Z14-044

5074 East Dublin-Granville Road

Rocky Fork Blacklick Accord Advisory Panel

Planning Staff Comments

Subarea D Site Plan

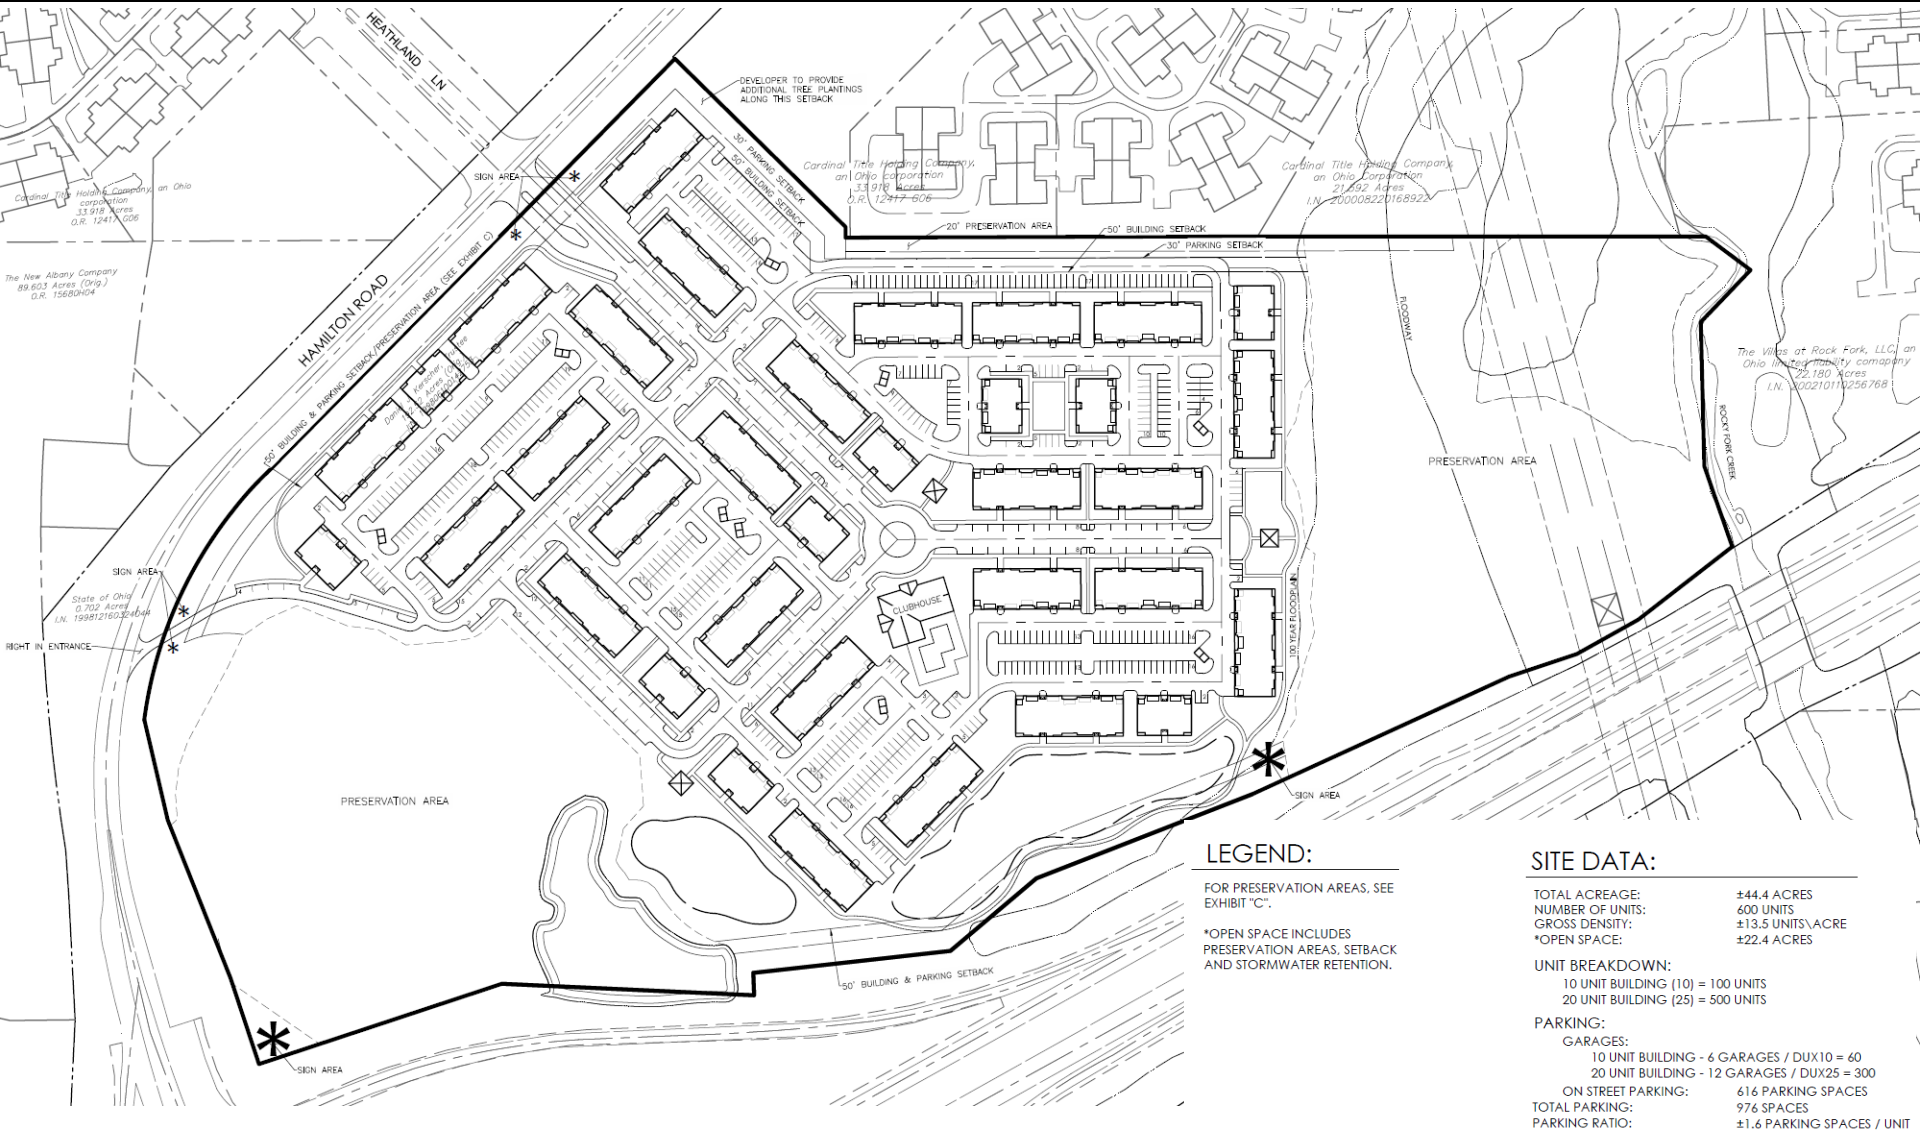
NE Corner SR 161/Hamilton (Subarea D):

- Consider 4 story buildings for the SR 161 frontage to allow for greater open space.
- Additional detail/color elevations are needed to better evaluate the architectural elements of the buildings generally.
- Describe/illustrate the exposure of the buildings that face the southwest corner of the site (buildings east and northeast of the pond and clubhouse) and SR161.
- Staff would like to see a text commitment to keep the storm water retention away from the preservation areas.

Subarea E: Site Plan

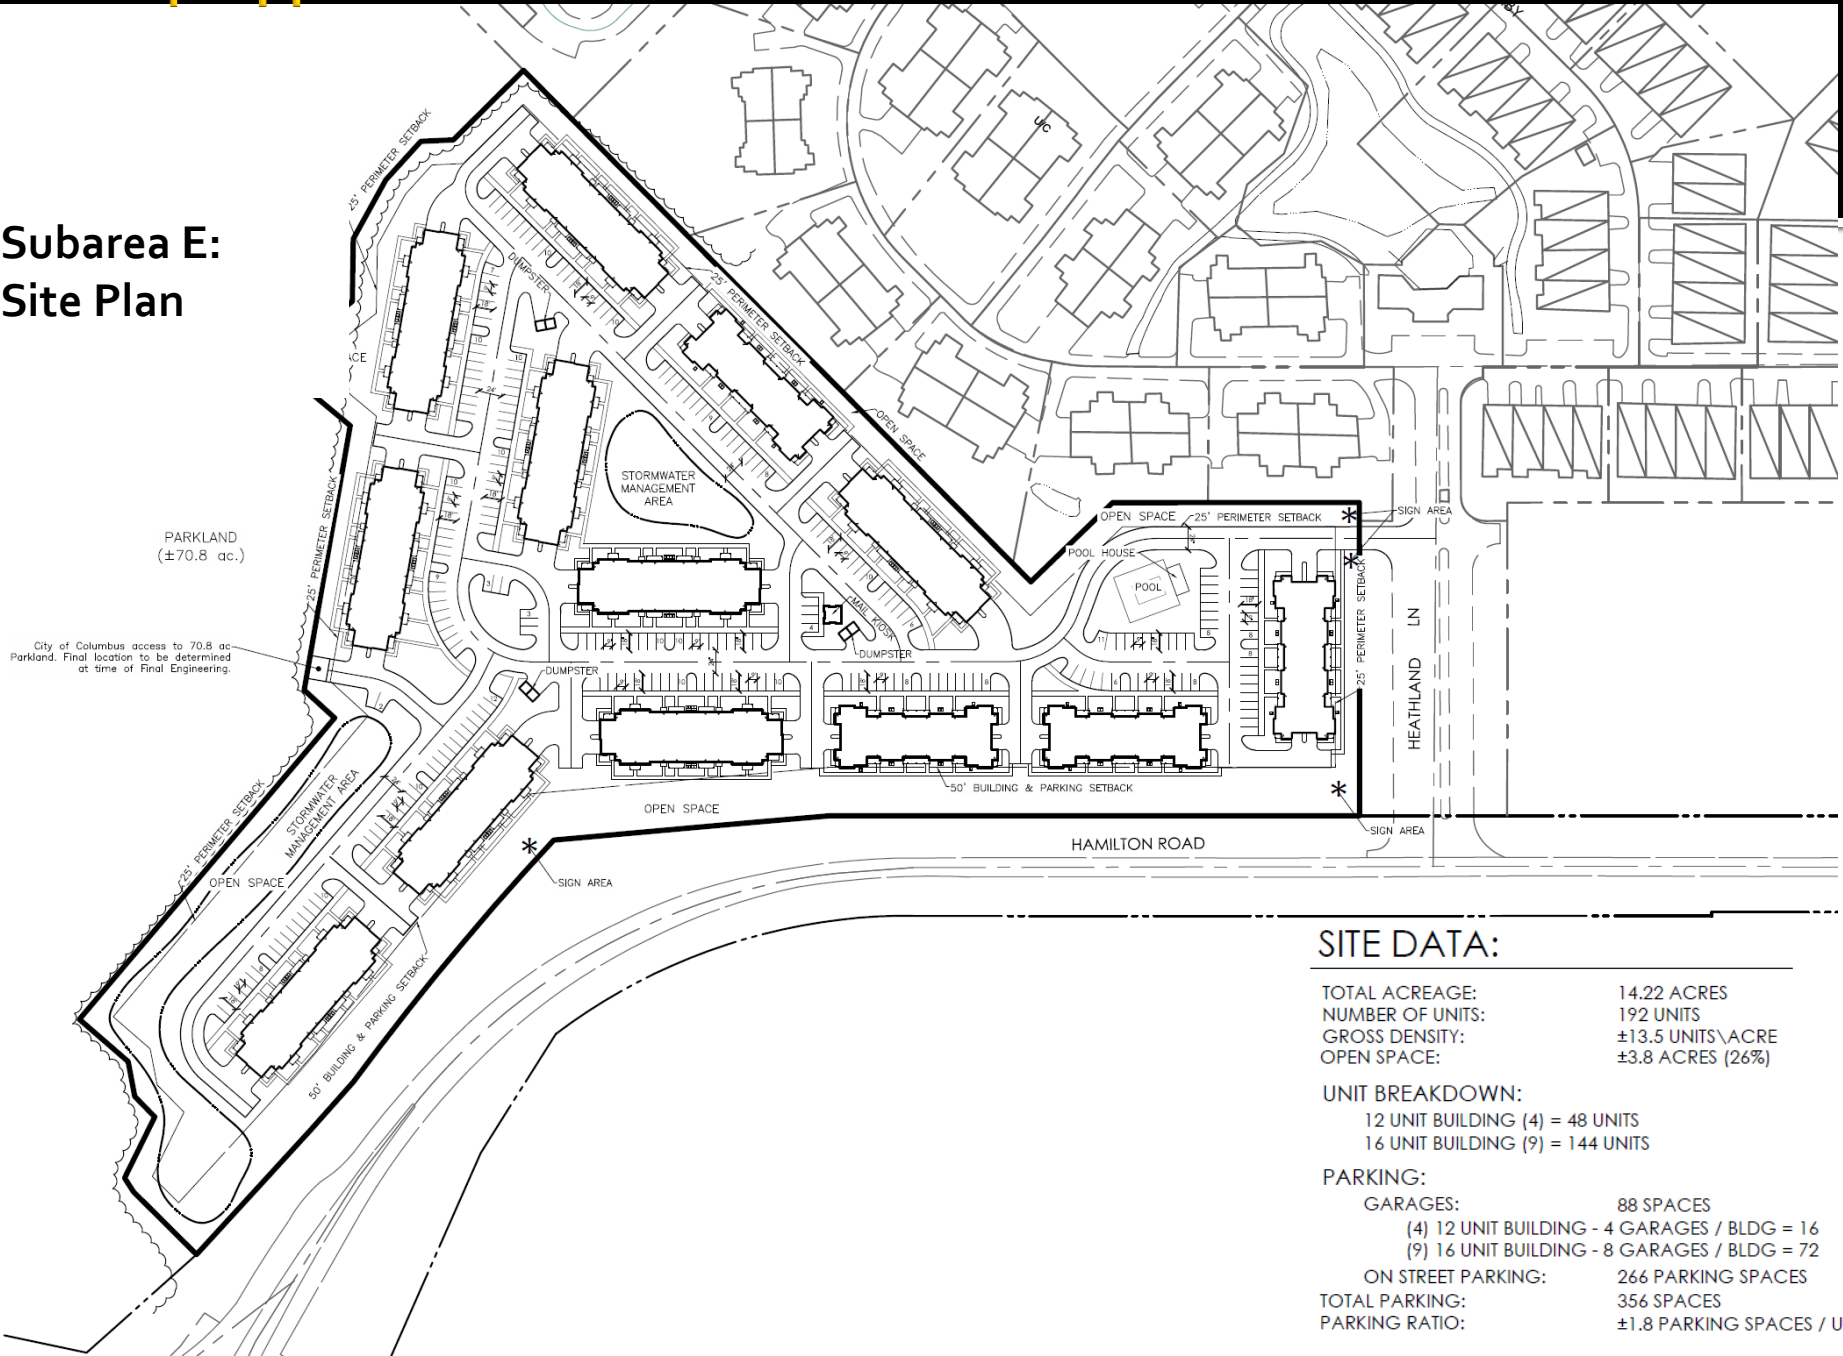
NW Corner SR 161/Hamilton (Subarea E):

- Consider 3 story buildings for the Hamilton Road frontage to allow for greater open space.
- Staff recognizes that the property's configuration makes efficient site layout challenging, staff encourages the applicant to reconfigure the site to include more usable open space.
- Staff encourages the applicant to allow for a greater setback from the wooded portion of the western border.
- Staff asks for clarification regarding the building elevations that will face Hamilton Road.
- Staff would like to see a text commitment to keep the storm water retention away from the preservation areas.
